# JONES & BEACH ENGINEERS INC.

**RE: Response Letter – Peer Review**  
**635 Sagamore Ave, Portsmouth, NH**  
**Tax Map 222, Lot 19**  
**JBE Project No. 18134.1**

We are in receipt of comments from Eric Weinrieb, P.E., Altus Engineering dated June 4, 2024. Review comments are listed below with our responses in bold. In addition to the below comments, the City DPW requested two changes to the plans and drainage model at an on-site meeting with Mike Garrepy of 635 Sagamore Development, LLC on July 24<sup>th</sup>, 2024 while the new test pits were being dug.

DRAWING No.  
**C2**  
SHEET 4 OF 20  
JBE PROJECT NO. 18134.1

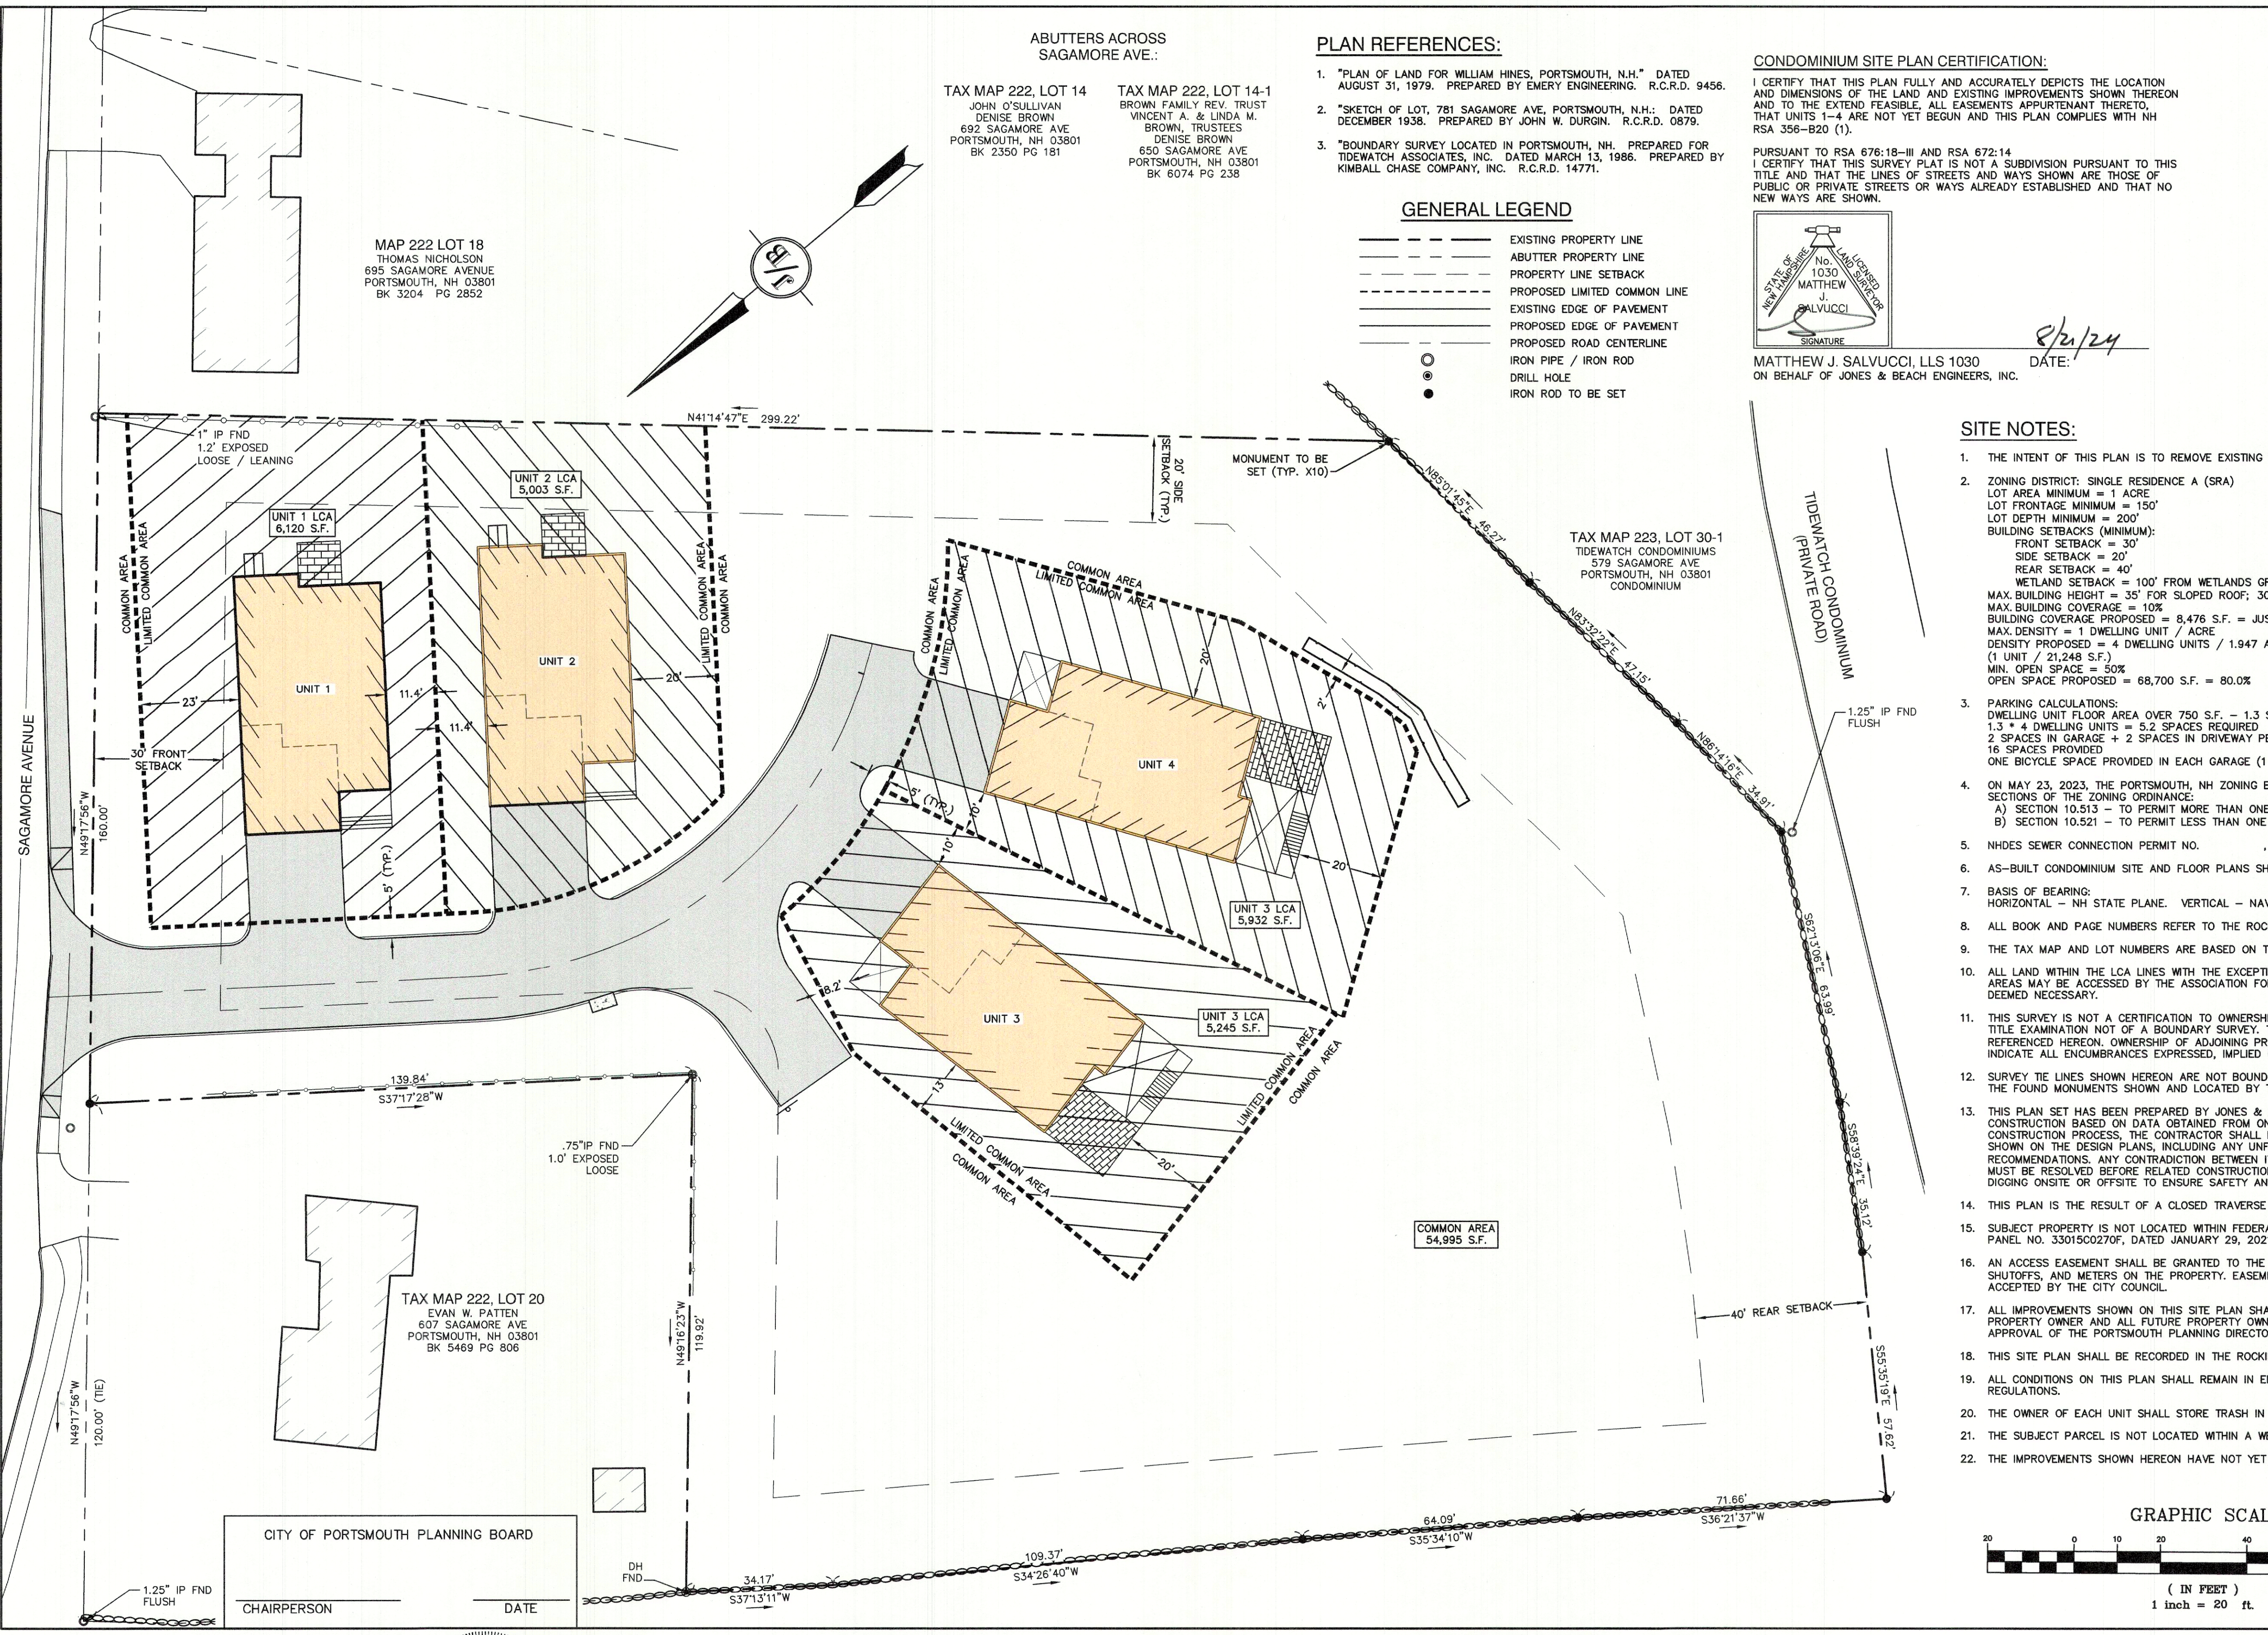
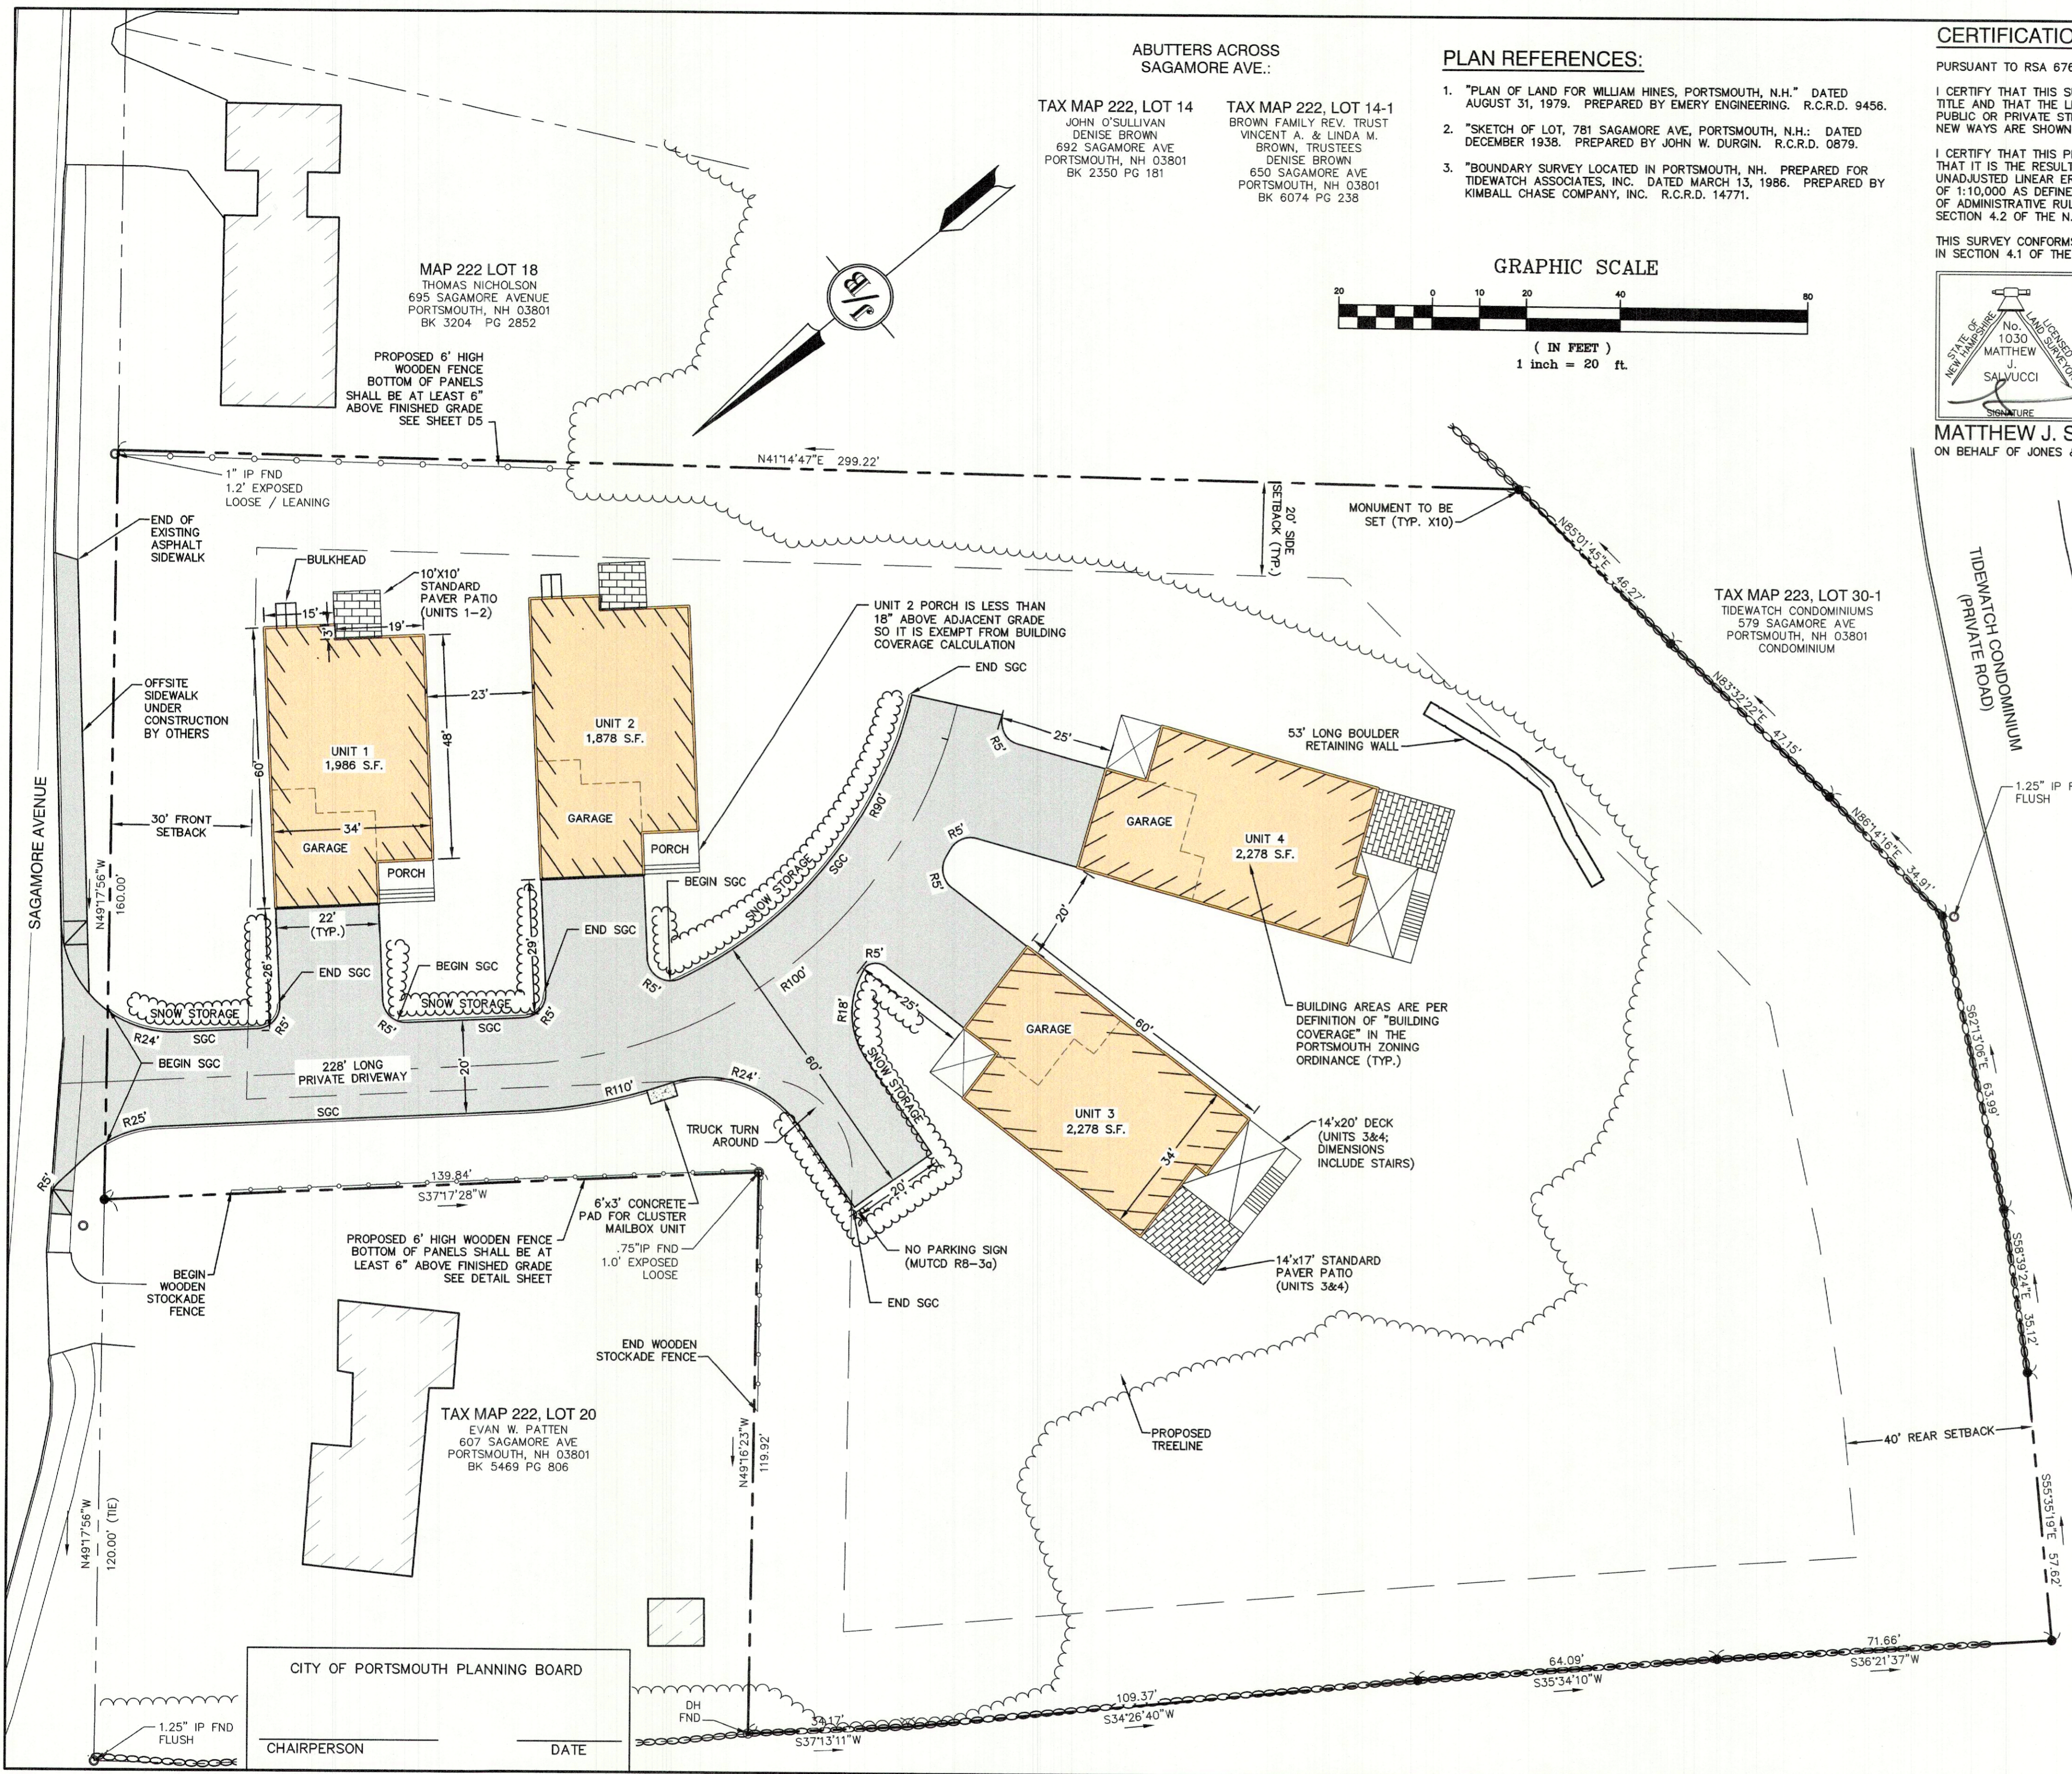
7. Based on the Cuomo report and Altus' observations, note 6 on Sheet C2 needs to be corrected. The 100-foot wetland buffer extends onto the property. The buffer should be depicted on the plans.

**RESPONSE:** Brenden Walden, CWS, and Mike Cuomo, CWS, determined in the field that the wetlands on the Tidewatch Condominium property are well offsite. See attached letter from RCCD. It is apparent that the proposed disturbance is outside of the wetland buffer, because the proposed disturbance is approximately 100 feet from the far edge of pavement of the Tidewatch Condominium roadway at its closest point. Note #6 on Sheet C2 has been revised.

DRAWING No.  
**C3**  
SHEET 6 OF 20  
JBE PROJECT NO. 18134.1

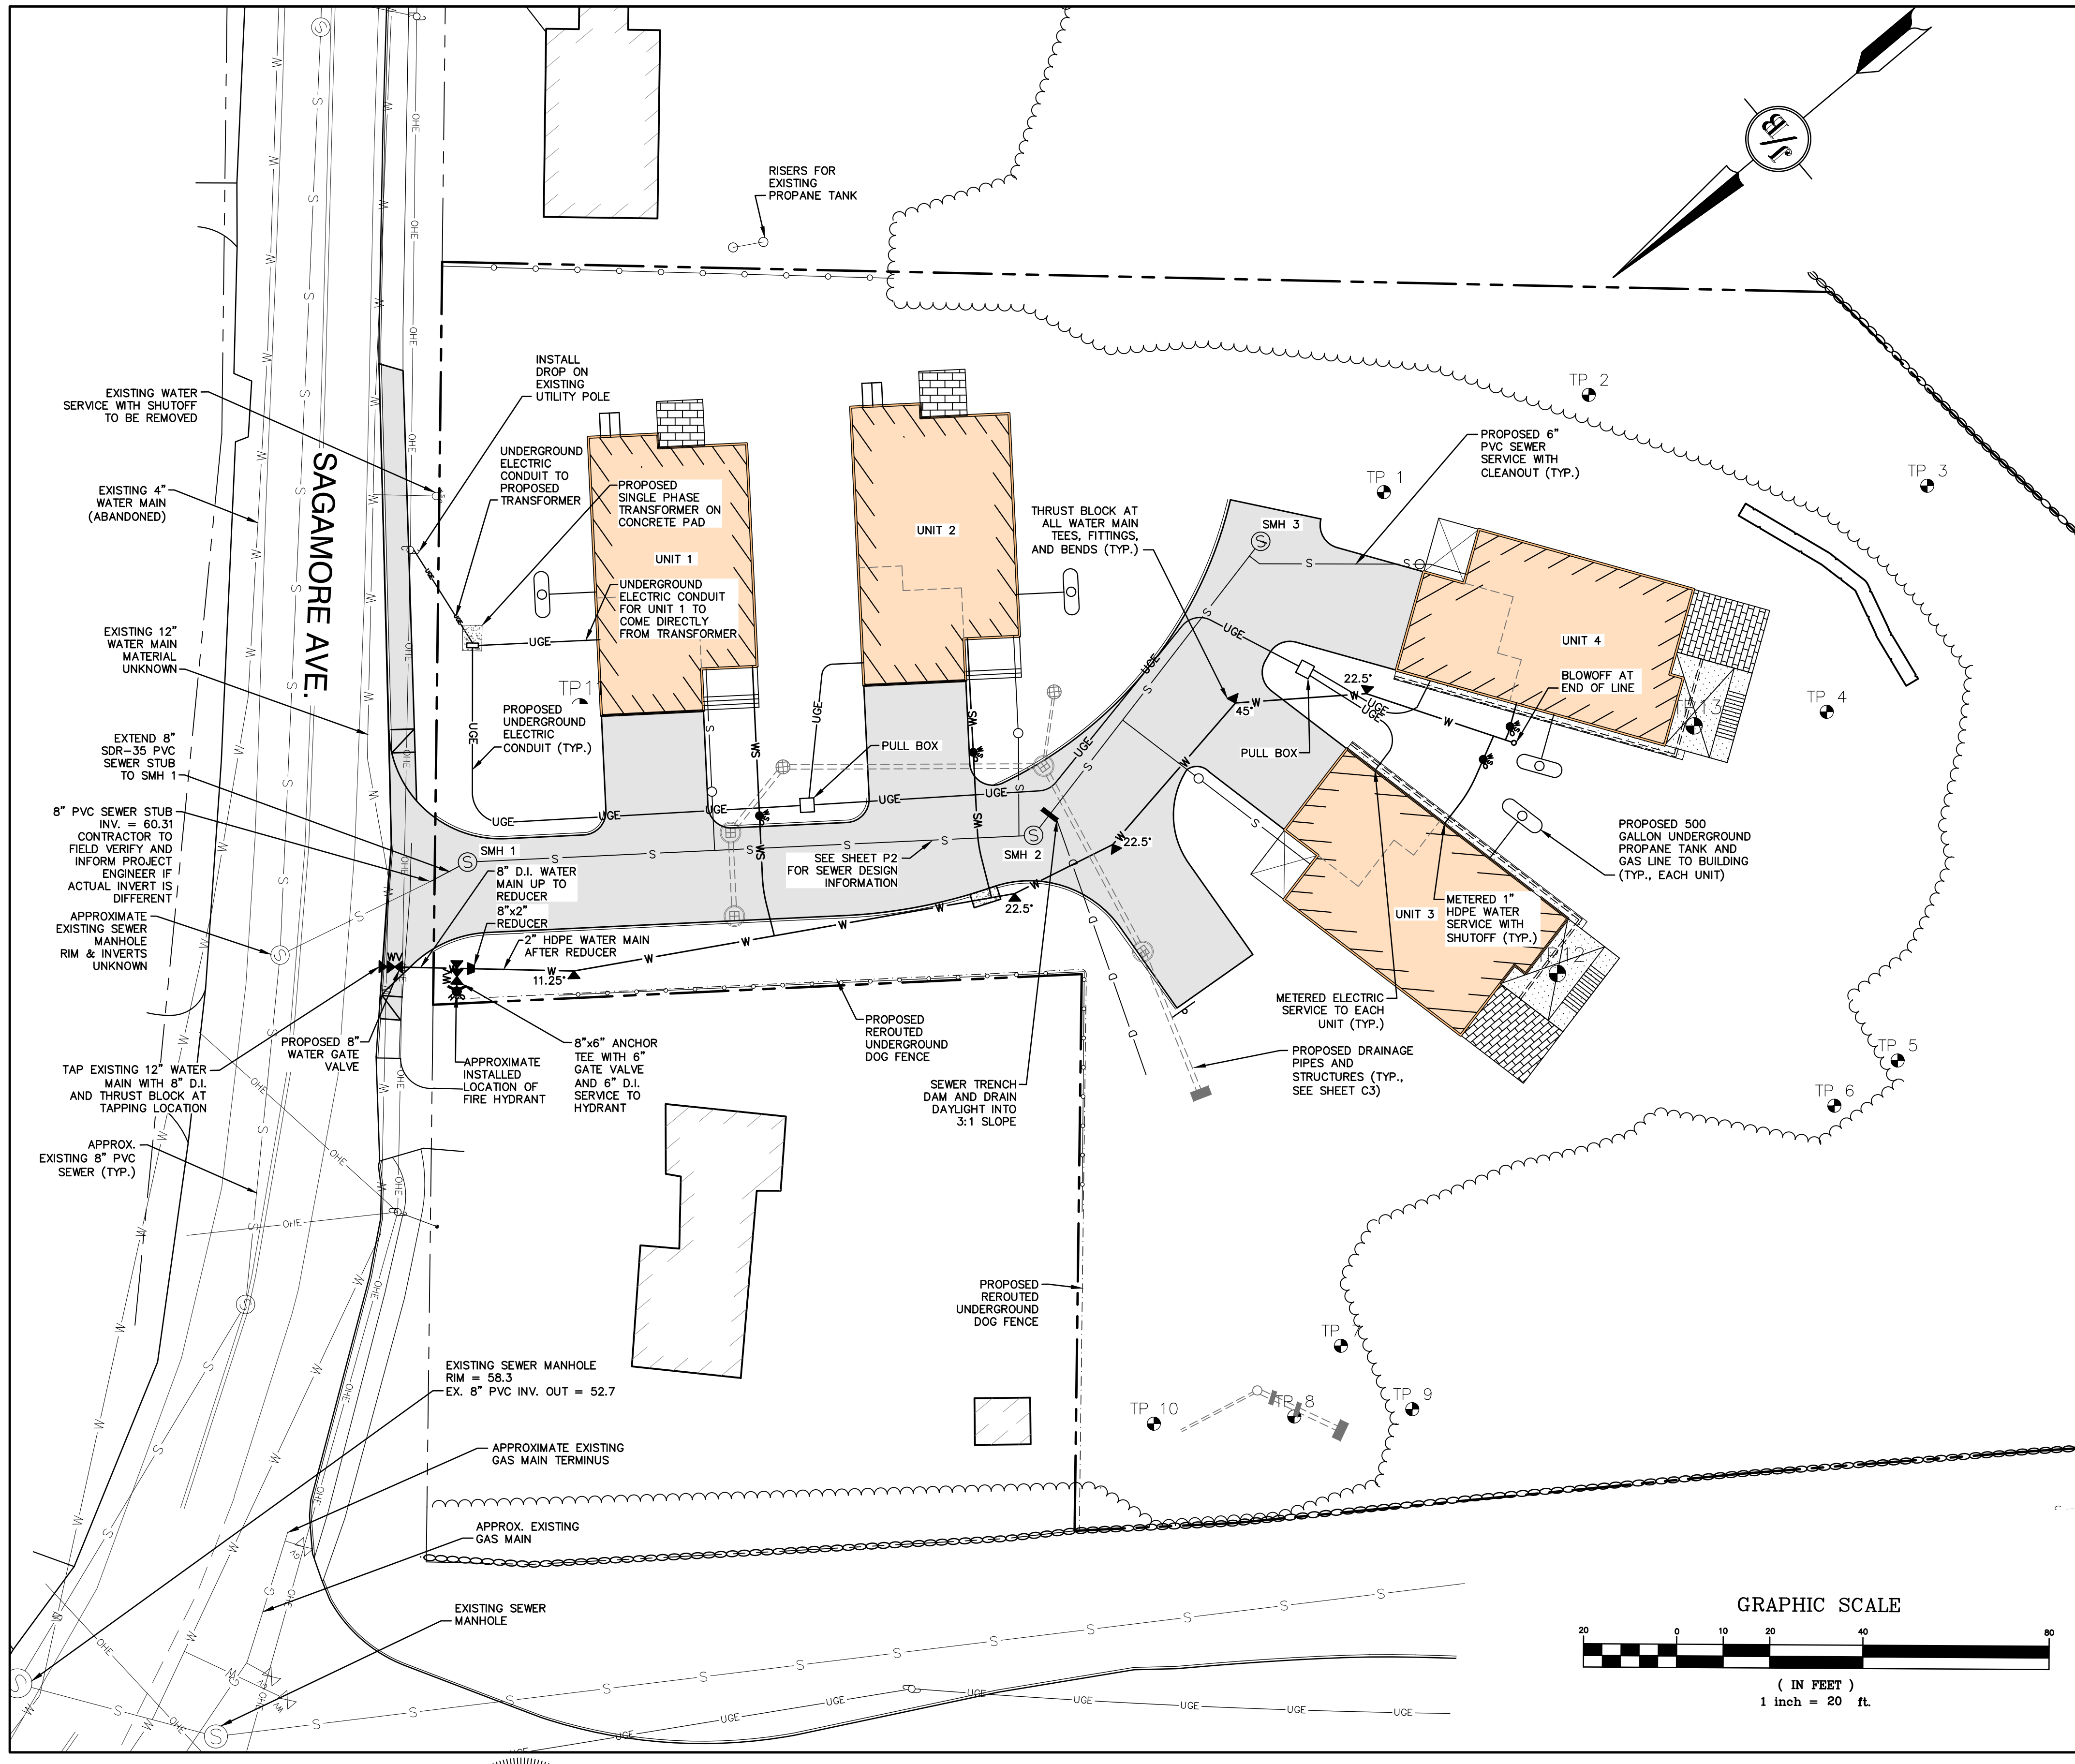
*4. Additional proposed spot grades are suggested to ensure that the transition from a super elevated roadway to a crowned roadway will properly drain.*

**RESPONSE: Additional spot grades have been added to the grading and drainage plan to ensure that this section of the roadway will properly drain.**
